From: [Janet & David](#)
To: [Figueroa Cole, Yannette](#); [Galindez, Mario F.](#); [Board of Public Works](#)
Subject: PONTIAC TRAIL PROJECT
Date: Tuesday, November 18, 2025 5:08:58 PM

From: [Layne Larson](#)
To: [Board of Public Works](#)
Subject: Public Comments and Exhibits - Pontiac Trail - Agenda Item 5 - Pontiac Trail
Date: Tuesday, November 18, 2025 1:36:27 PM
Attachments: [Option 1 vs 3 Summary.pdf](#)
[Pontiac Trail - Option 3 Public Comment.pdf](#)
[Pontiac Trail Exhibits -- 11-18-2025B Exhibit.pdf](#)

Pontiac, Boston, Nokomis, and Rosewood Reconstruction

Exhibit A -- Overbuilt Design Contradicts Green Streets Principles

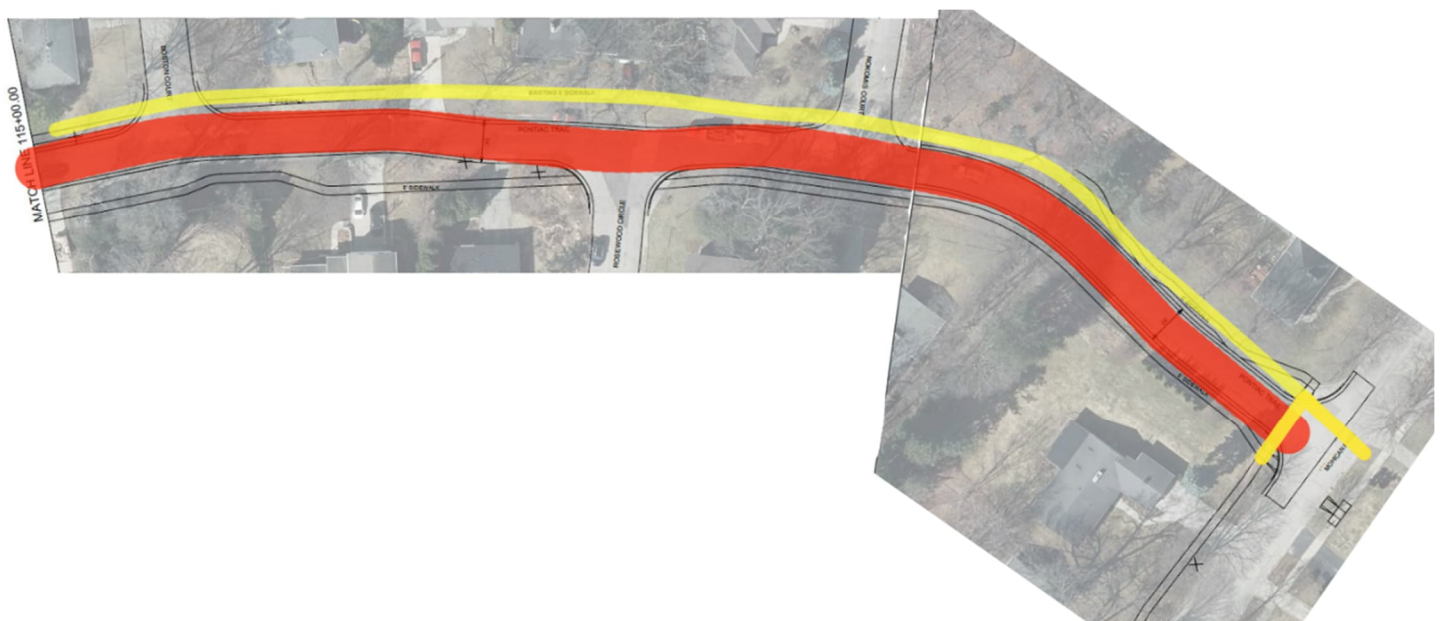
Figure 2 - Middle Segment – Sidewalk on west side (yellow). Road (red) is aligned to preserve greenspace. On the East side there would continue to be green space and canopy trees. Sidewalk shown on plans would not be built to preserve the x out trees and allow additional plantings, rain gardens and vegetation.

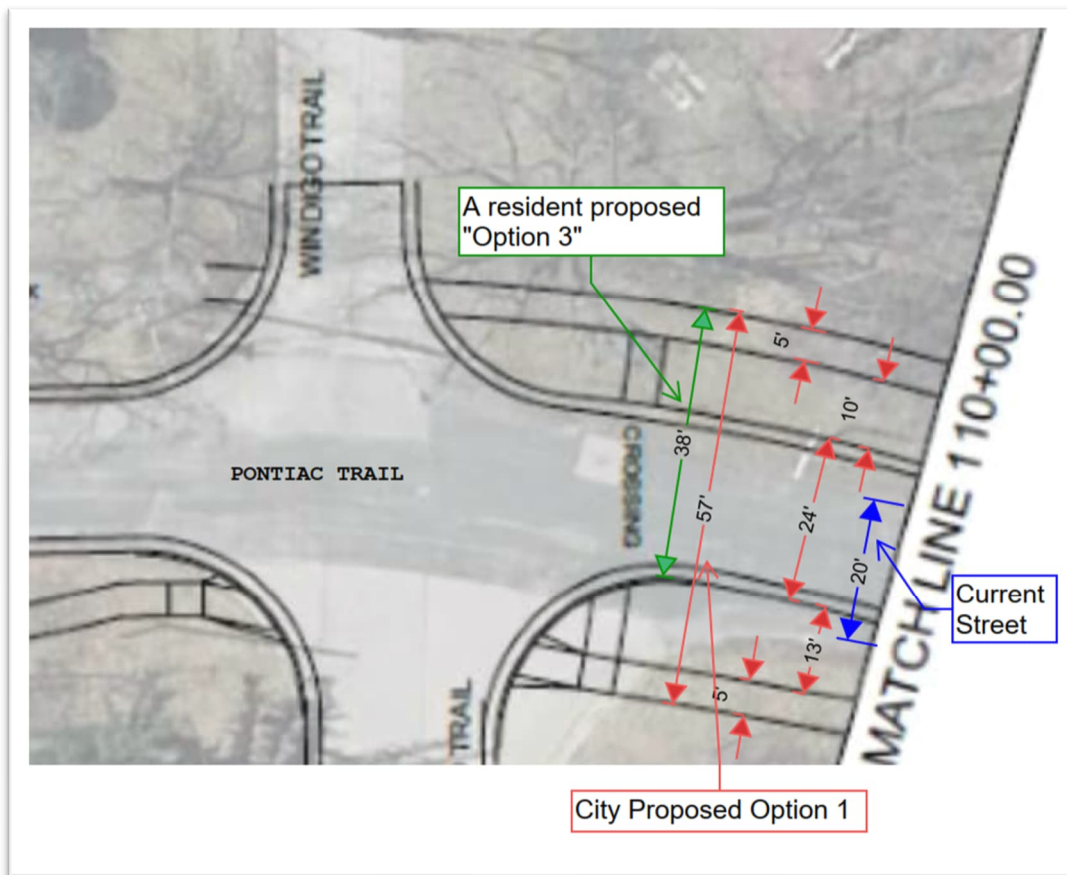
The Guide is explicit: “There is no one design of a Complete Street.” A cross section nearly three times wider than the existing does not reflect that context-first approach. “Streets should be designed for today’s needs, with additional right of way reserved for the future if needed.” (Page 7 GSG)

The new design is almost 3x wider than the current street!

Is this design truly responsive to neighborhood scale and character? Does it reflect the Guide’s call for restraint, balance, and environmental sensitivity?

Accessibility Issue 2 – Double Street Crossing from Zook Park to the Southwest Path

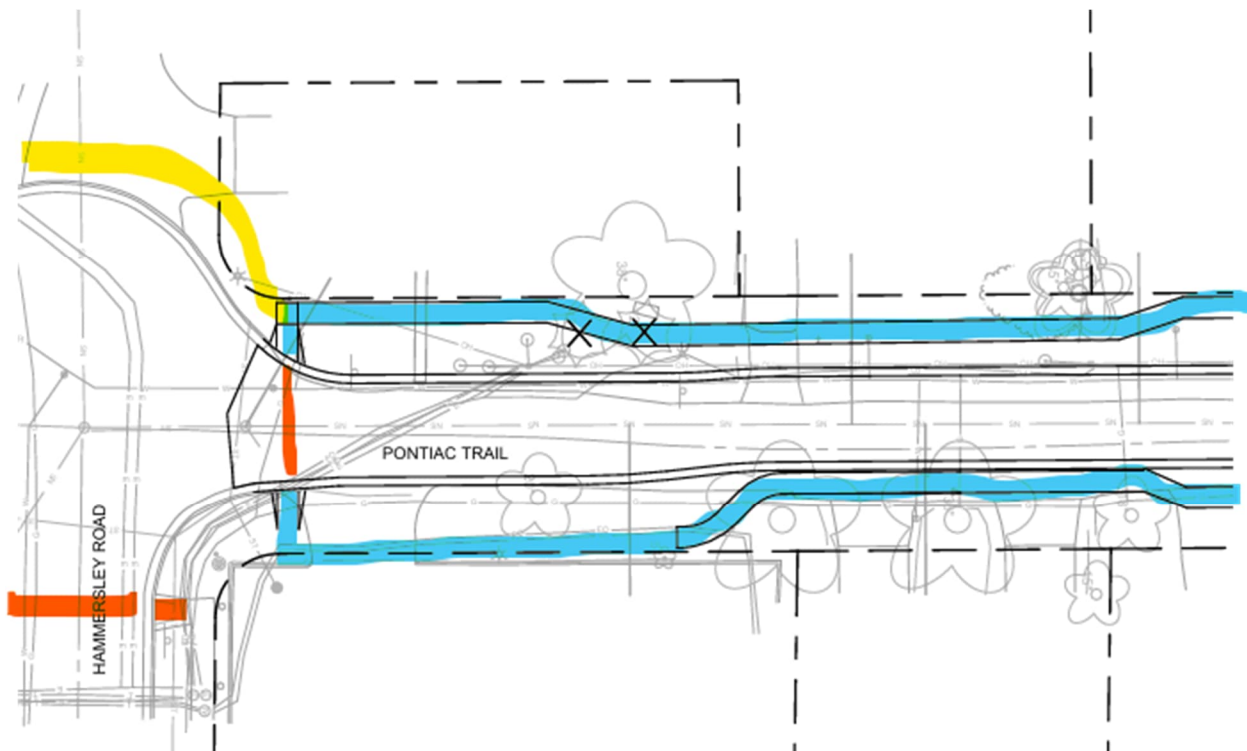
The most useful route along Pontiac Trail would be to connect Zook Park with the Southwest path. The current design doesn't do that without requiring pedestrians to cross the street twice. This raises a critical question: why will this not be addressed? Forcing multiple crossings adds unnecessary complexity and risk, particularly for users with disabilities.

Red Highlights: The current design requires two street crossings to travel from the Southwest Path to Zook Park. An unnecessary burden for residents with mobility or vision challenges. Blue Highlights: Proposed and existing sidewalk segments. Yellow Highlight: Route to Southwest Path.
